Final Environmental Assessment

Wallooskee-Youngs Confluence Restoration Project

Bonneville Power Administration
DOE/EA-1974
July 2015

Public Comments

Figure 3-4: Cross Section Depicting Visual Impacts to Motorists Along OR 202

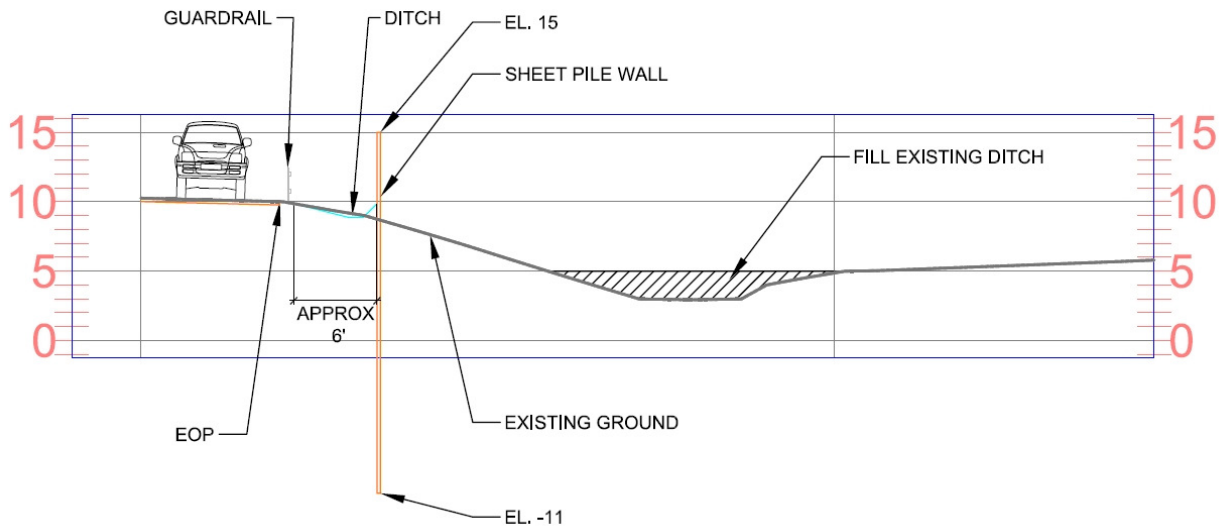
Additional analysis has been added to section 3.8.2.2 in aesthetics and visual resources regarding the final design for the sheet pile wall along OR 202 (Page 3-57, second paragraph).

Everyday I have a very pleasurable nature experience on my travels down Highway 202 on my way to Olney. I can not believe that sheet piling along the highway has any value to a real nature experience. This is not the natural solution to the road issue. If the project is completed I would hope we can see a more effective and pleasing solution to provide the protection of the road.

The sheet pile wall would add an industrial element to the northern border of the site, visible as a long, but narrow, linear feature adjacent to the site. The sheet pile wall would be adjacent to OR 202, an existing linear manmade landscape feature and would blend into this feature when viewed from a distance. The properties to the south and west of OR 202, on the other side of the Wallooskee and Youngs rivers, would not likely be impacted due to the distance (0.8 mile) from the sheet pile wall. The exposed portion of the sheet pile wall, below OR 202, would be visible from within the project area or the Youngs River (greater than 0.3 mile away). The wall would also be visible from OR 202, and may block views for some motorists into the project site, ~~as it would extend up to five feet above the road surface elevation along approximately 500 linear feet of OR 202.~~ The sheet pile wall would extend along OR 202 for a total length of approximately 800 feet. The sheet pile wall's height would be approximately 4 to 5 feet above the road grade of OR 202 for 500 feet and would gradually decrease for the remaining 300 feet as the road climbs the upland knoll to the southeast. Photograph 3 shows the view from the northern tile shop driveway entrance along OR 202 into the project area. This photograph is located in the area where the sheet pile wall would extend 4 to 5 feet above the road grade. ~~This is the low point of OR 202 and in this area the sheet pile wall would extend 4 to 5 feet above the pavement.~~ A portion of the sheet pile wall would be screened by a guard rail; however, it is expected that the wall ~~will~~ would limit the views into the site for some motorists and patrons of the tile shop. A cross section depicting the maximum visual impact to motorists along OR 202 from the sheet pile wall is provided in below in Figure 3-4. The potential visual impacts of the sheet pile wall are considered moderate, since views of the wall ~~are~~ would be limited due to distances but views into the site from OR 202 would be impaired.

Thank you for your comment. As discussed in section 2.3.3 extensive effort was put into finding alternative ODOT wind-wave mitigation features prior to arriving at the sheet pile alternative. Using a

sheet pile wall to protect OR 202 was determined to be the only feasible highway protection approach after geotechnical analysis. A vegetated earthen berm was originally considered for highway protection, with a low slope (10 feet horizontal to 1 foot vertical) to dissipate wave energy. To fully dissipate the effects of the wind-wave energy, the berm would have needed to be built along OR 202 to an elevation 1 foot lower than the proposed sheet pile wall. Constructing a berm this high would have required the filling of approximately 4 acres of wetland, detracting from the restoration area and ecological value. Additionally, the weight of an earthen berm would have impacted the adjacent highway due to compressible soils underlying OR 202, causing the roadway to sag as much as 1 to 2 feet requiring additional repairs to the highway and greatly increasing flooding concerns. The appearance of the sheet pile wall was considered in design and discussed in section 3.8.1 of the EA.
